F 002.346	Dian 2.0 Comments
C/ 00 SC Shimon Muller	Р	L	# 10004	C/ 00 SC 46.1.3 Booth, Brad
Comment Type E	Comment Status X			Comment Type E Comr
All the new clauses "CSMA/CD MAC".	for 10-GE should use the term	ו "802.3 MAC" rather	r than	change "Sonet STS-192c" to be
SuggestedRemedy				SuggestedRemedy Fix.If STS is going to be used ins the draft.
Proposed Response	Response Status O			Proposed Response Res
C/ 00 SC	Р	L	# 49002	C/ 00 SC 46.1.3
clause 48, 49 comment	resolution			Tom Mathey

P802.3ae	Draft 2.0	Comments
----------	-----------	----------

Note: Figure 54-7 is contained in the file http://www.ieee802.org/3/ae/comments/d2.0/dolfi\_1\_0101.pdf

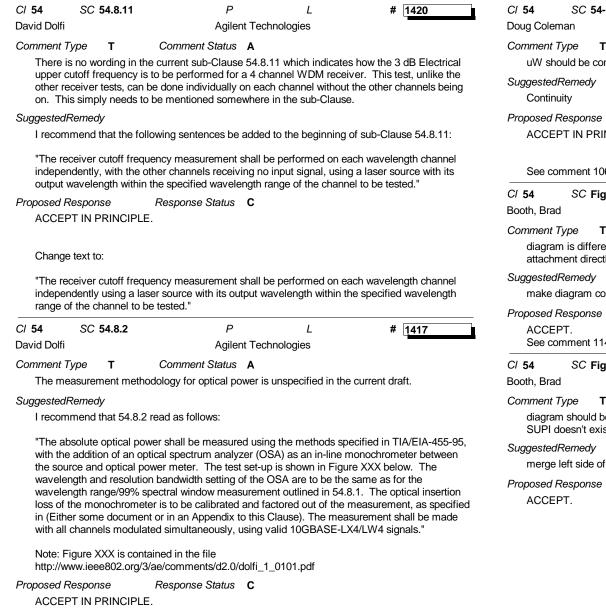
\_\_\_GHz fourth-order Bessel Thompson filter to the oscilloscope input. Special care should be taken to ensure that all the light from the fiber is collected by the fast photodetector and that there is negligible mode selective loss, especially in the optical attenuator.

The source for the channel under test shall be set to supply a signal at the output of the optical multiplexer which is at a -5 dB power level with respect to the other channels. Each channel is to be tested with its adjacent channels set at the near end of their wavelength range. This is to occur sequentially, as described in 54.xxx.yyy. The channel under test is to be tuned over its wavelength range during a given measurement to account for wavelength dependent losses within the channel."
